## IV. DRAFT EIR REVISIONS

This section presents text changes for the *Parkmerced Project Draft Environmental Impact Report*. The Draft EIR text changes reflect revisions developed in response to comments and staff-initiated text changes to clarify information. The revisions are organized by EIR section and, as in the responses in this Comments and Responses document, deleted text is ~~struck through~~ and new text is underlined. The text additions and revisions presented below clarify and expand the information presented in the Draft EIR. The revised text does not provide new information that identifies new significant environmental impacts; the clarified and expanded information does not identify mitigation measures that, if implemented, would result in significant environmental impacts; and considerably different alternatives and/or mitigation measures were not identified that would clearly lessen the significant environmental impacts of the proposed project.

**FIGURE V.E.4: PROPOSED TRANSIT IMPROVEMENTS (REVISED)**

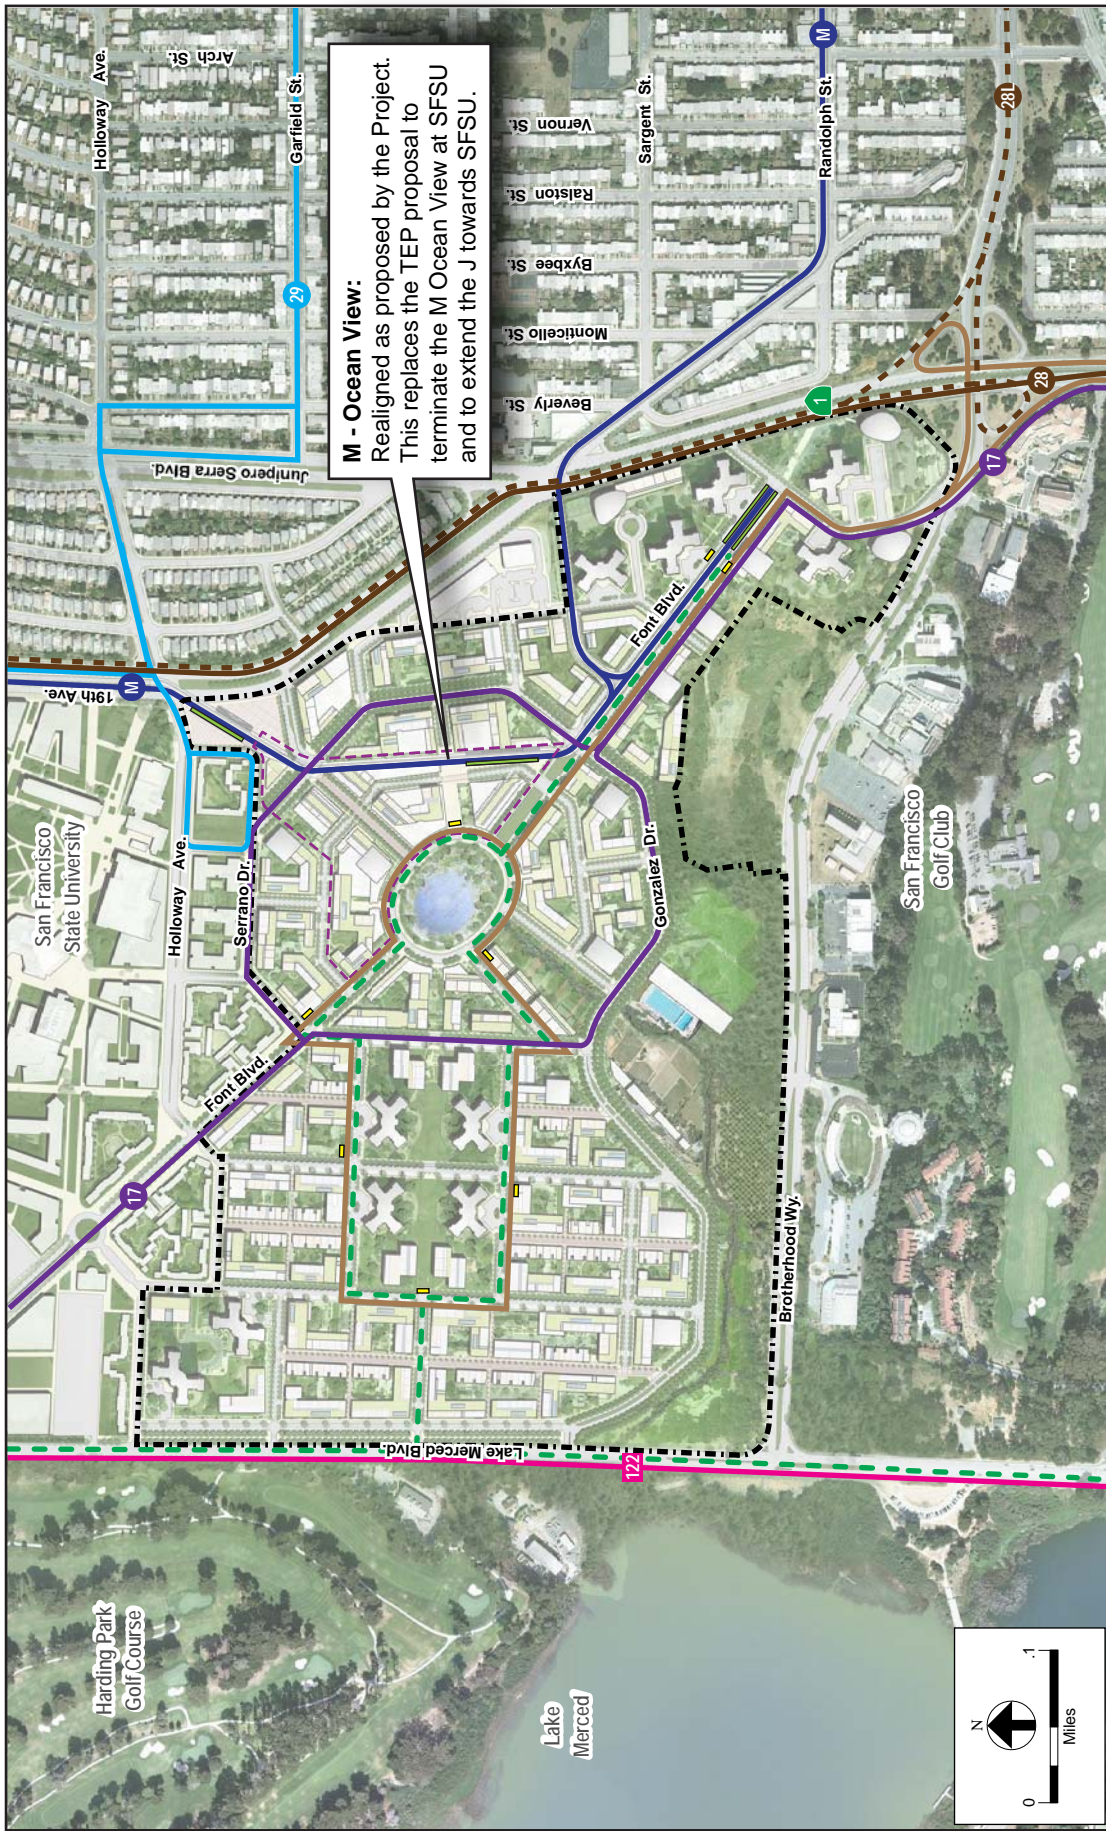
A staff-initiated text change has been made to Figure V.E.4: Proposed Transit Improvements, on p. V.E.33. The revised figure is shown on p. IV.10.

**FIGURE V.E.6: PROPOSED BICYCLE CIRCULATION IMPROVEMENTS (REVISED)**

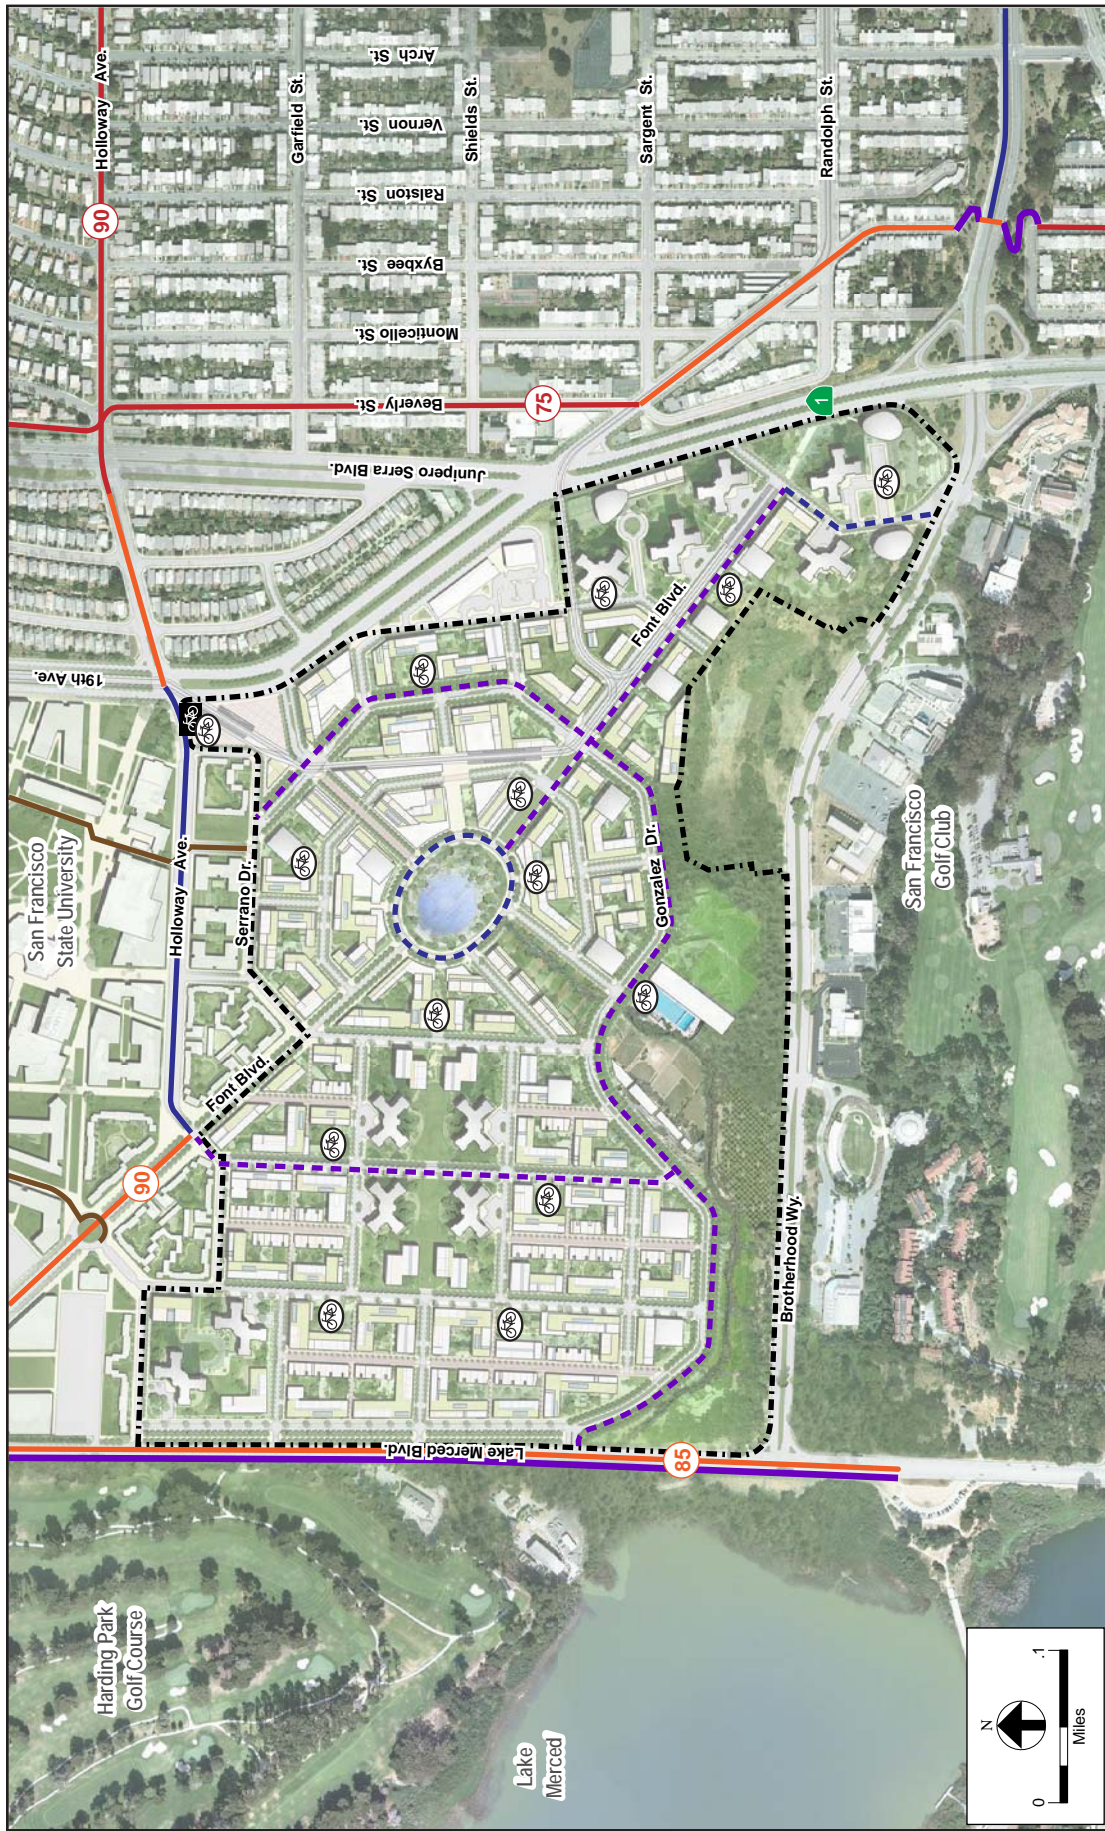
A staff-initiated text change has been made to Figure V.E.6: Proposed Bicycle Circulation Improvements, on p. V.E.39. The revised figure is shown on p. IV.12.
